ZONING BOARD OF APPEALS STAFF REPORT

REGARDING: 26150 NOVI ROAD (PZ16-0019), Parcel 50-22-14-351-057 & 50-22-14-351-058

Response Letter

Planning Review dated May 16, 2016

PRELIMINARY SITE PLAN

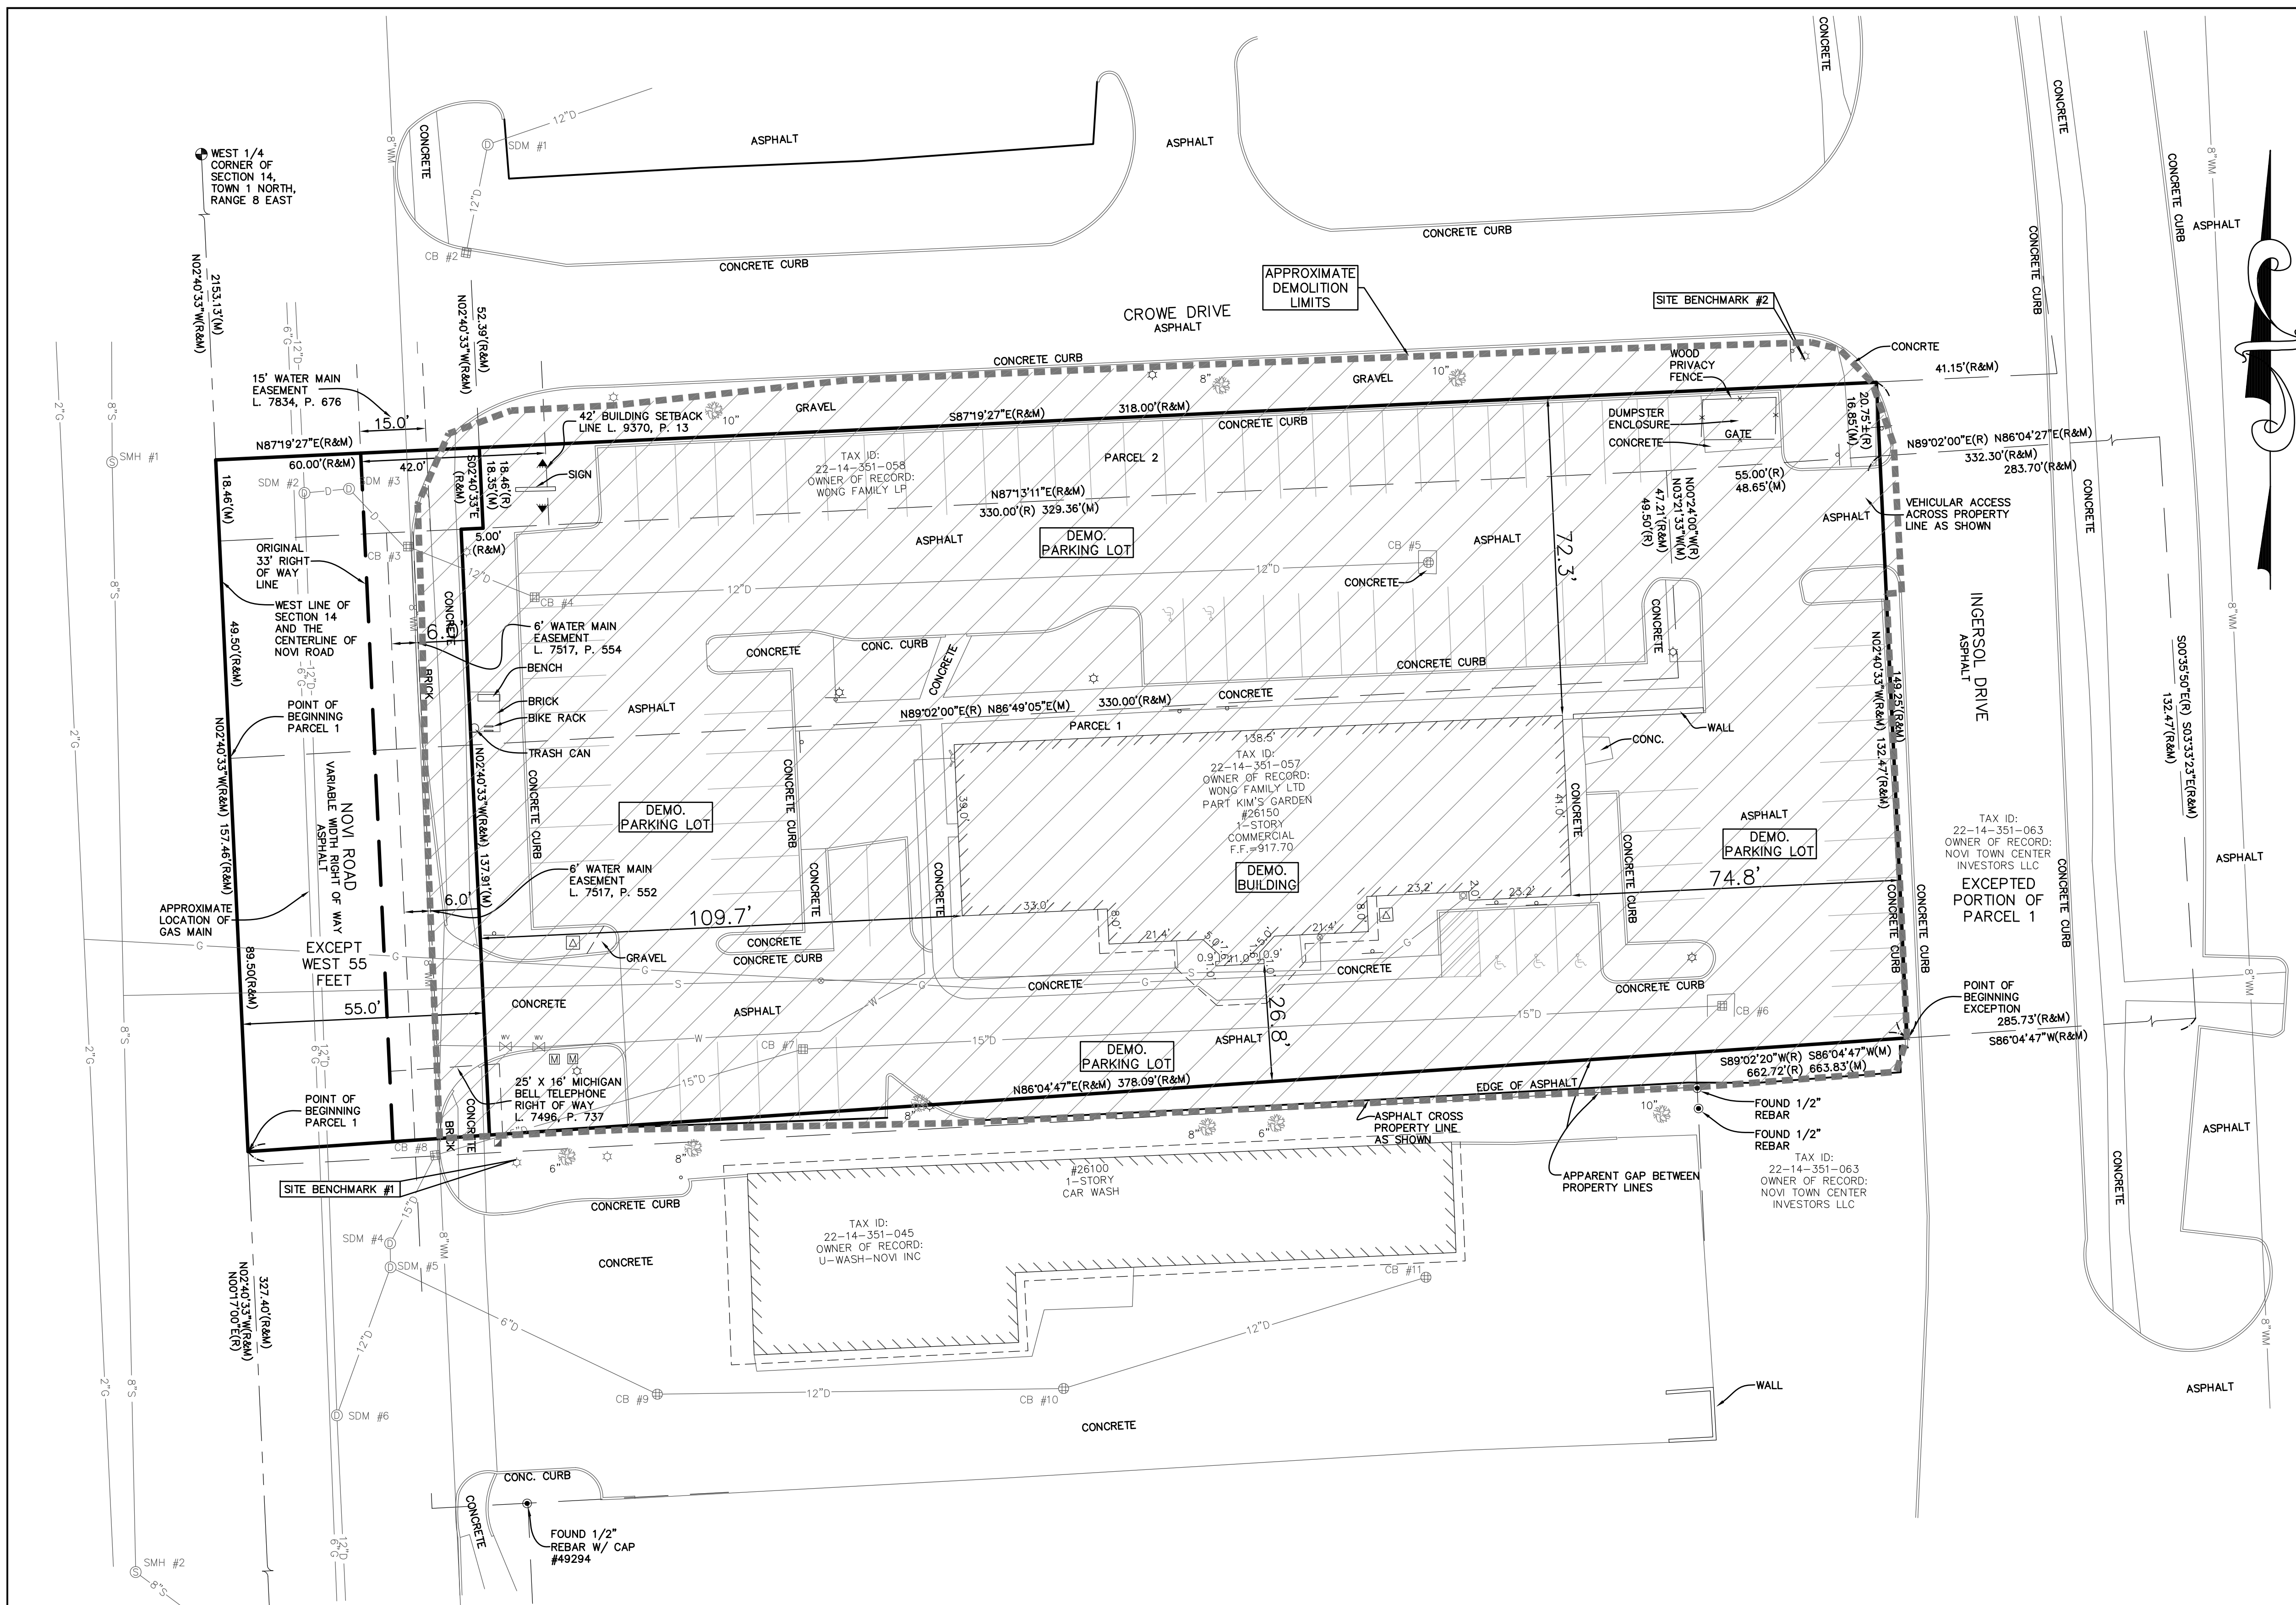
1. The two parcels will be combined prior to final site plan approval.
2. Building Setbacks (Sec. 3.1.25.D): Buildings in the TC District must be setback 50 feet from all property lines.
The plan indicates reductions to 14.7 ft. setback in the front (Novi Road), 15 ft. setback in the exterior side (Crowe Road), and 11.4 ft. setback in the interior side (south). Building setback reductions are requested.

3. Parking Setbacks (Sec. 3.25.D): Parking in the TC District must be setback 20 ft. from the right-of-way line of any street or roadway. The plan indicates reductions to the setback from Crowe Rd. to 9.8 ft., Ingersol to 9.4 ft., and the interior side (south) to 0 ft (minimum). Parking setback reductions are being applied for to the Zoning Board of Appeals.
